**RE: Bronco Utah Operations LLC
Emery Mine
DOGM Permit No. C/015/0015
Emery 2 Subsidence Monitoring Plan Revision Resubmittal
Clean Copy Task 5567**

Title: e2 Phase II Subsidence Monitoring Plan Revision

Revise subsidence monitoring plan and update monitoring point locations resubmittal clean copy tsk 5567 1/18

PLATE V-5
 SUBSIDENCE MONITORING
 POINTS AND BUFFER ZONES

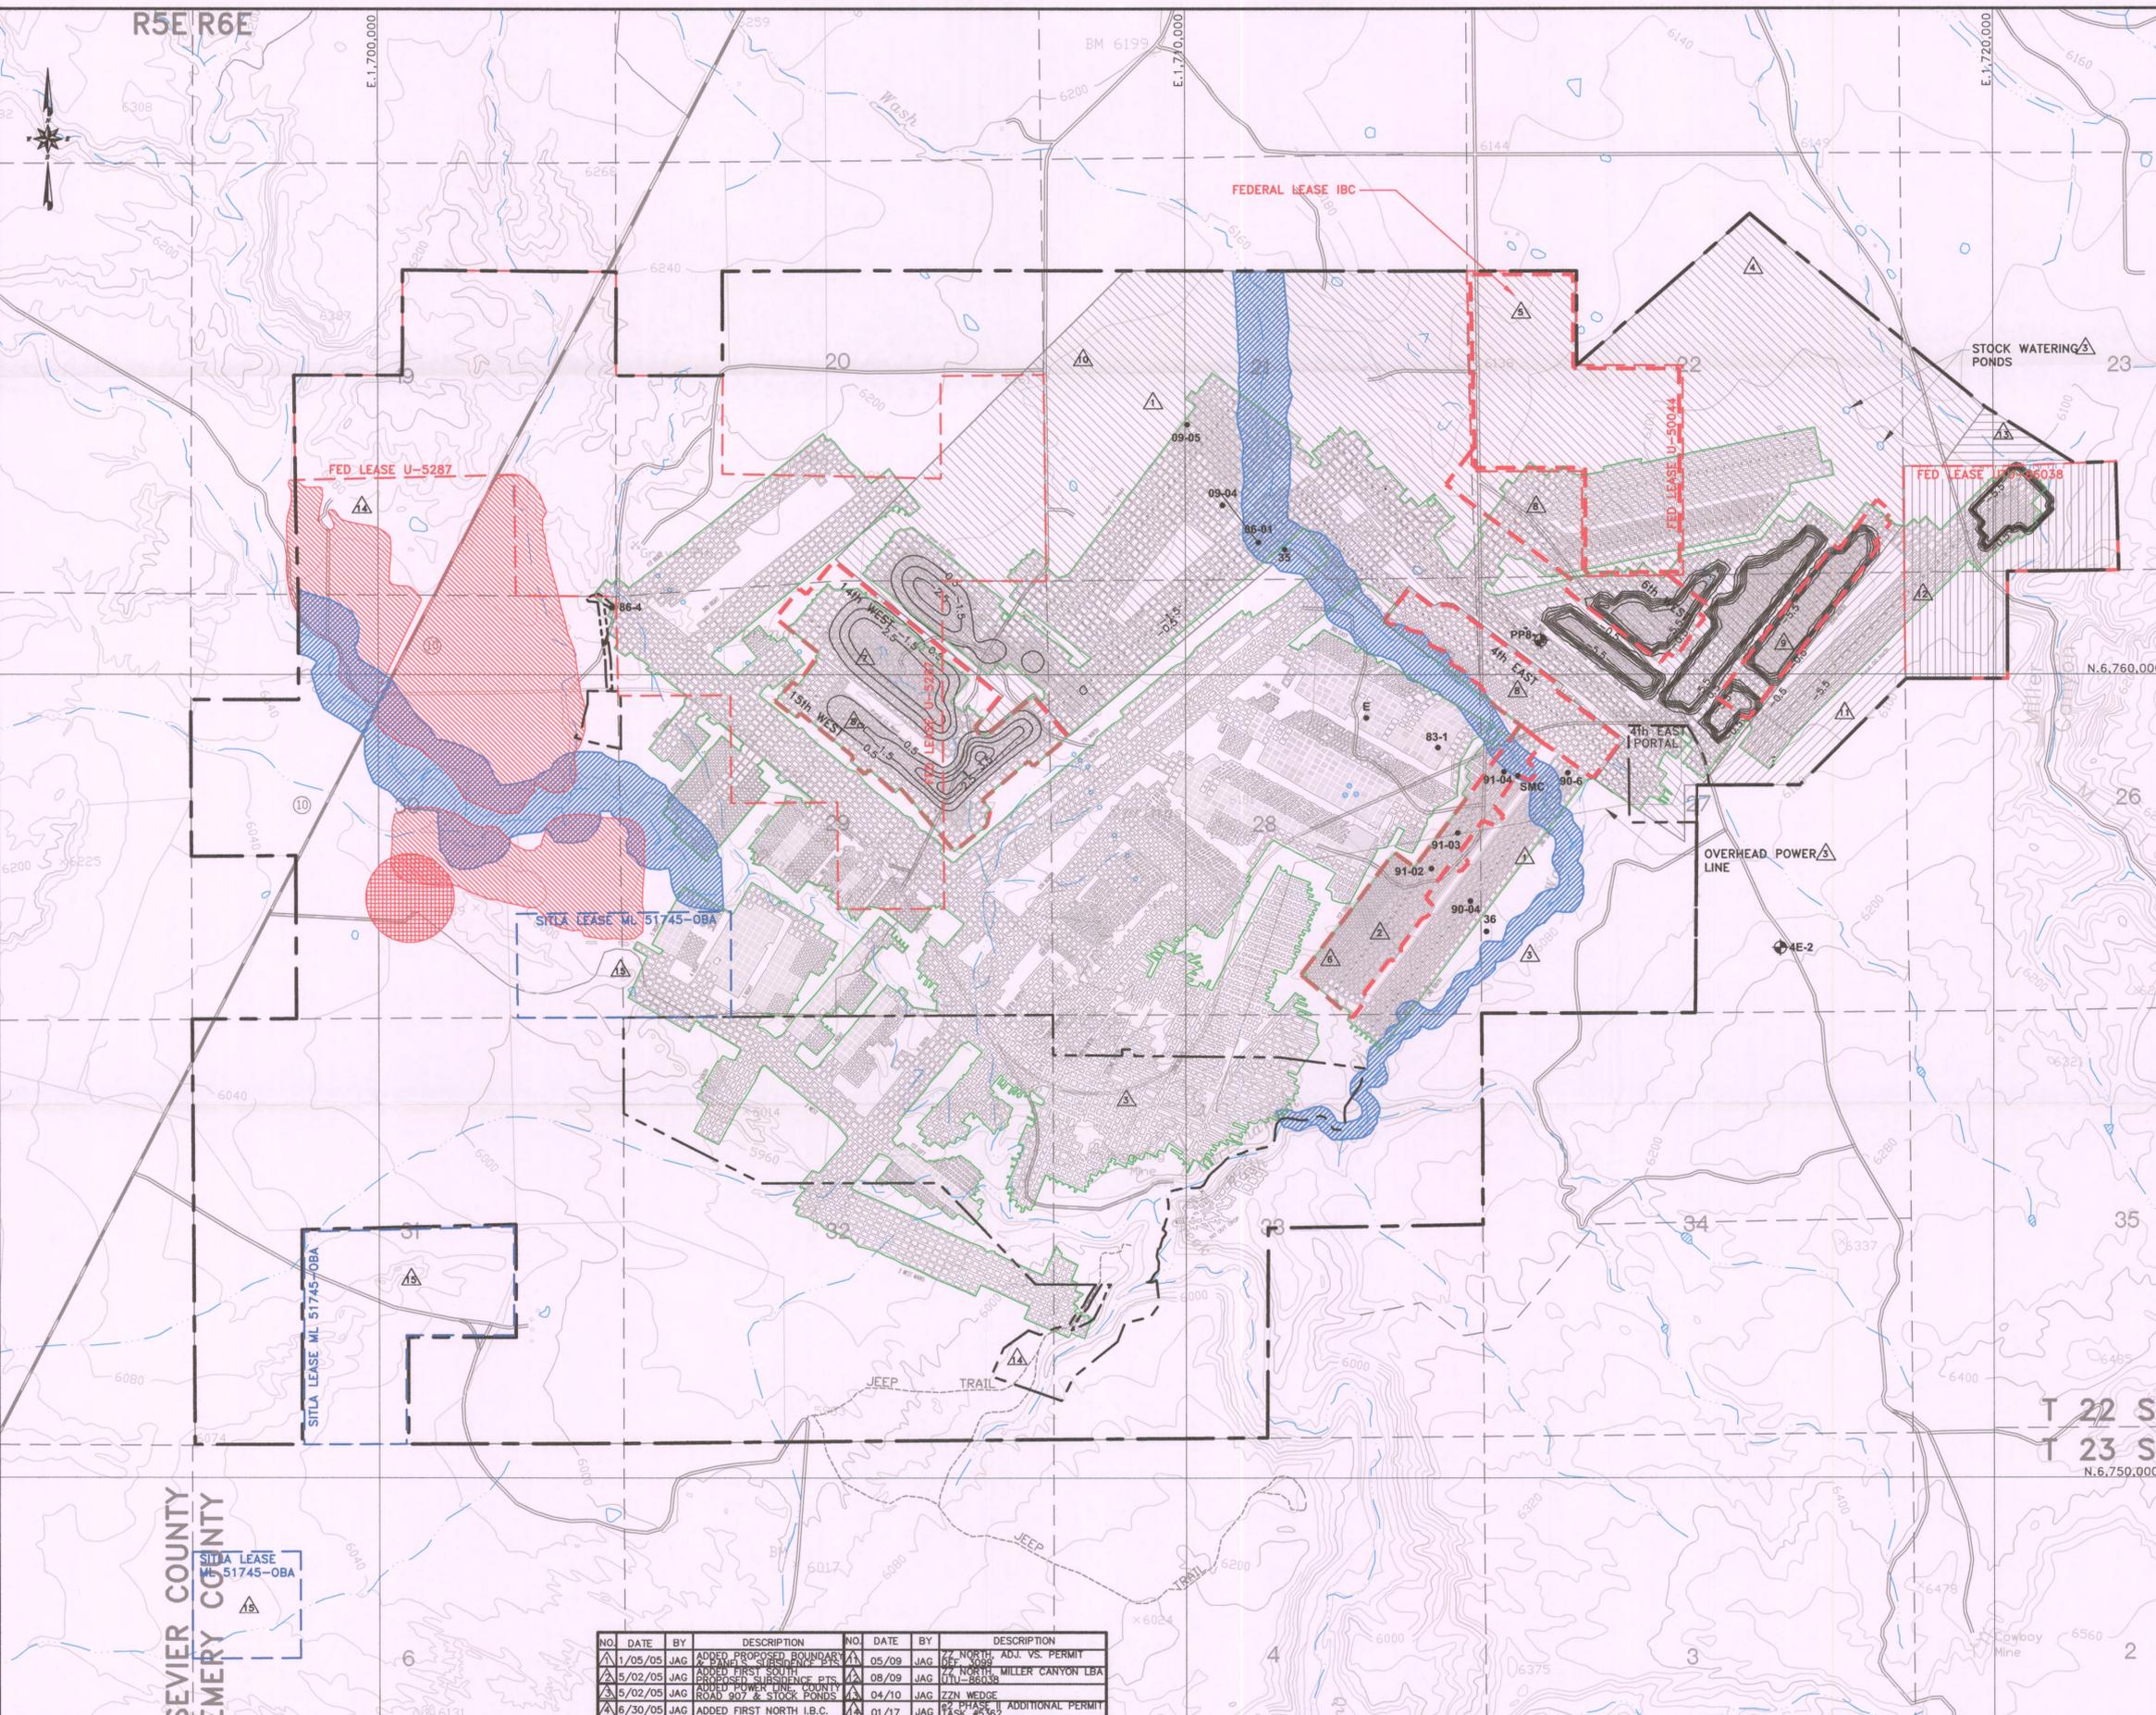
- 2.2.1 Subsidence monitoring points will, at a minimum, be established as depicted on Plate V-5:
 - At a point coincident to the geometric center of high extraction panels
 - At periodic intervals over mains and sub mains
- 2.2.2 Subsidence monitoring points will be set in a manner that will provide stability against monument movement and frost heave. Methods may include caps or steel bars set in concrete, steel bars embedded to refusal, or caps set in stone.
- 2.2.3 Plate V-5 depicts existing and proposed subsidence monitoring points.
- 2.2.4 Plate V-5H depicts subsidence monitoring points that no longer require a survey due to lack of historical movement.

Subsidence monitoring at the Emery mine has been ongoing since the early 1980s. Monitoring points were surveyed and depicted on Plate V-5 (Subsidence Monitoring Points and Buffer Zones). The survey data is submitted via the Annual Report in spreadsheet format. The monitoring points that no longer require a survey can be found on Plate V-5H (Historical Subsidence Monitoring Points). The 2016 Annual Report contains 10 years of historical survey data which supports discontinuing monitoring of these points due to less than 0.1 feet of movement.

PLATE V-5H
HISTORICAL SUBSIDENCE MONITORING POINTS

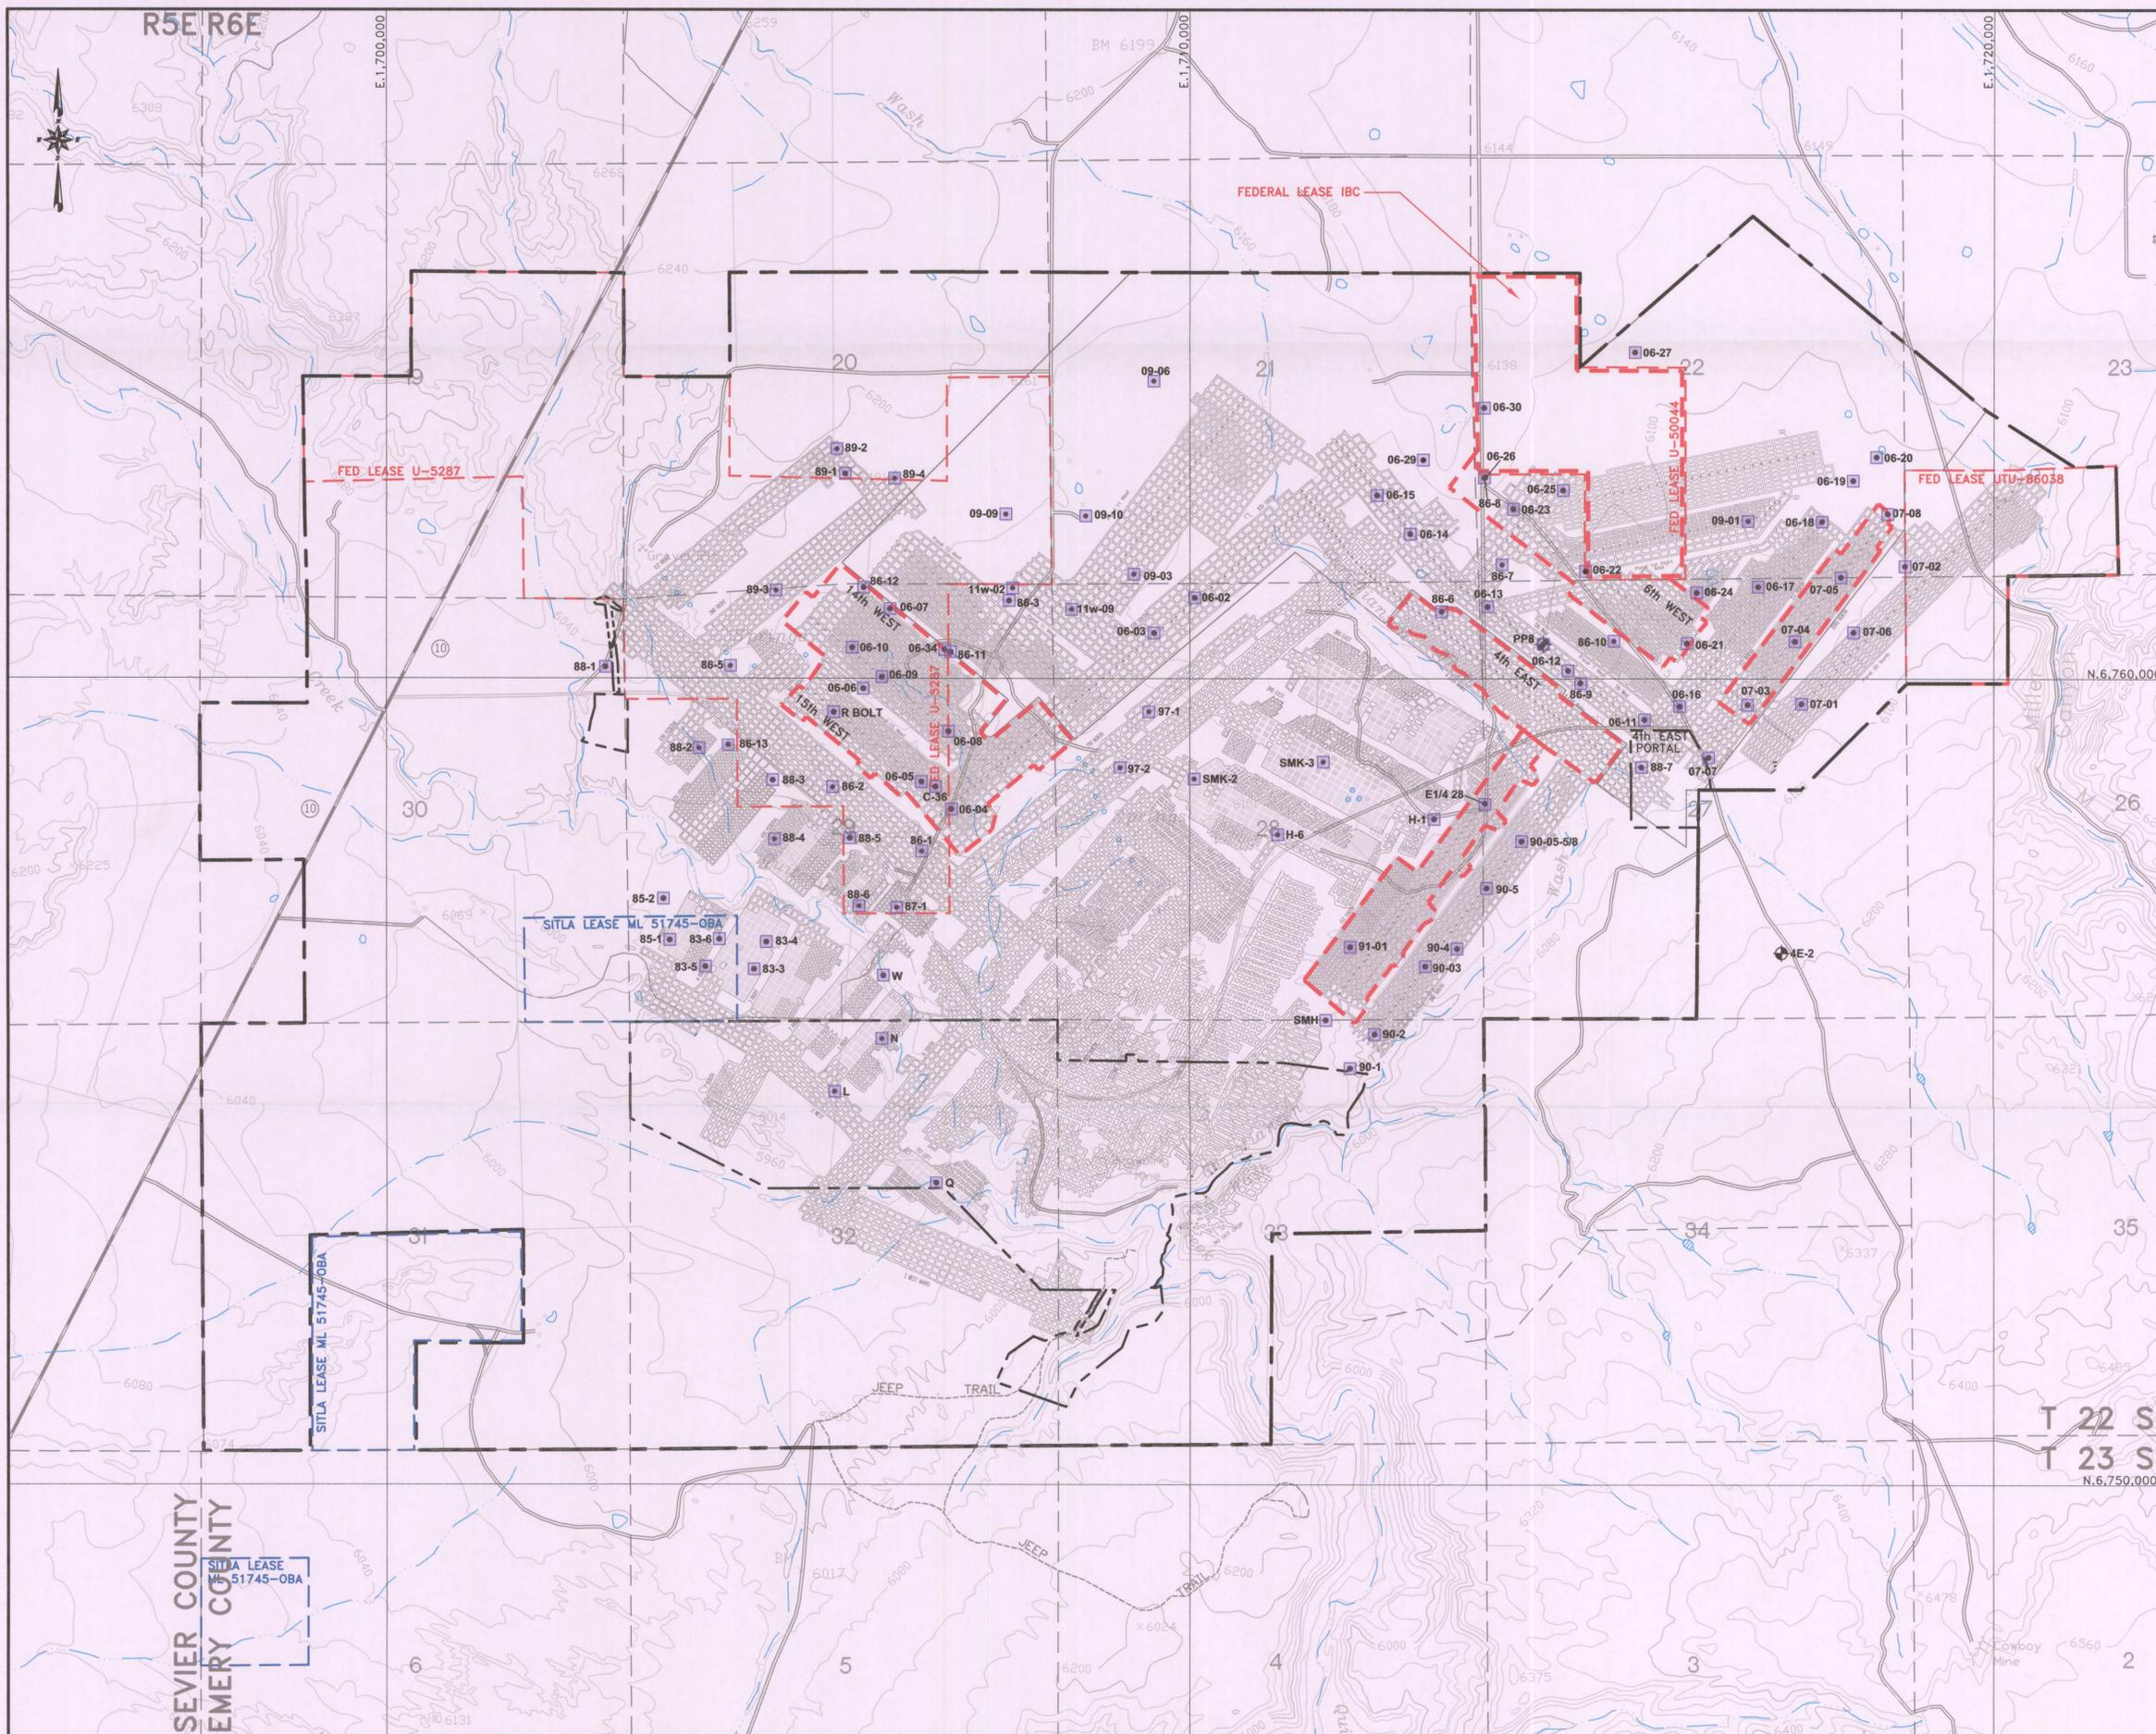
NO.	DATE	BY	DESCRIPTION	NO.	DATE	BY	DESCRIPTION
1	01/18	JAG	NEW PLATE TASK #5567
